SERVICE BULLETIN

Exchange of floats on ROTAX® Engine Type 912 and 914 (Series)

ATA System: 73-00-00 Fuel system

MANDATORY

Fig. 2

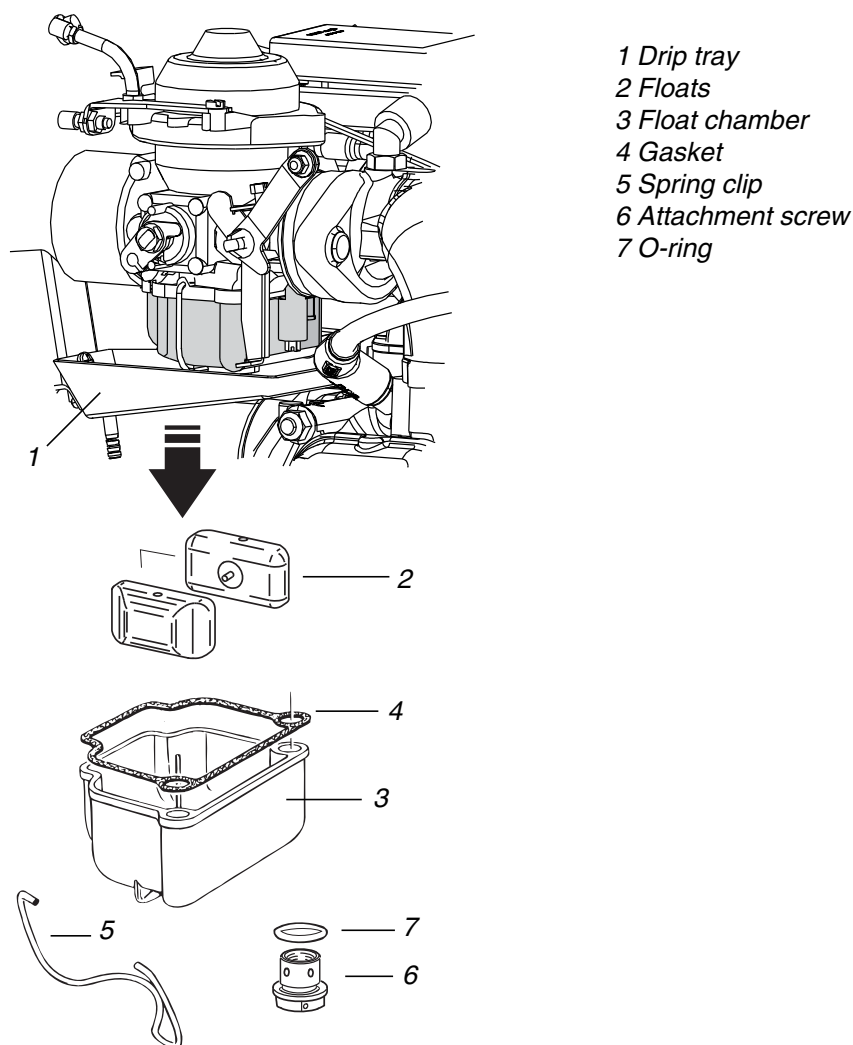
See Fig. 2.

Step	Procedure
1	Remove drip tray (1).
2	Visual inspection of the carburetor and its mechanical actuation.
3	Remove spring clip (5) or for ROTAX 914 Series remove safety wire, loosen cap screw (6) and remove with O-ring (7).
4	Remove float chamber (3), gasket (4) and the two floats (2)

Step	Procedure
1	Remove the gasket (4) from the float chamber and for ROTAX 914 Series exchange the O-ring (7).
2	Install float chamber (3) with gasket (4) and both floats (2).

Step	Procedure
3	Close spring clip (5) or for ROTAX 914 Series install the attachment screw (6) including O-Ring (7) and apply safety wire. Tightening torque of attachment screw 5.5 Nm (48.7 in.lb).
4	Install drip tray (1) and/or accessories according to the instructions of the aircraft manufacturer.
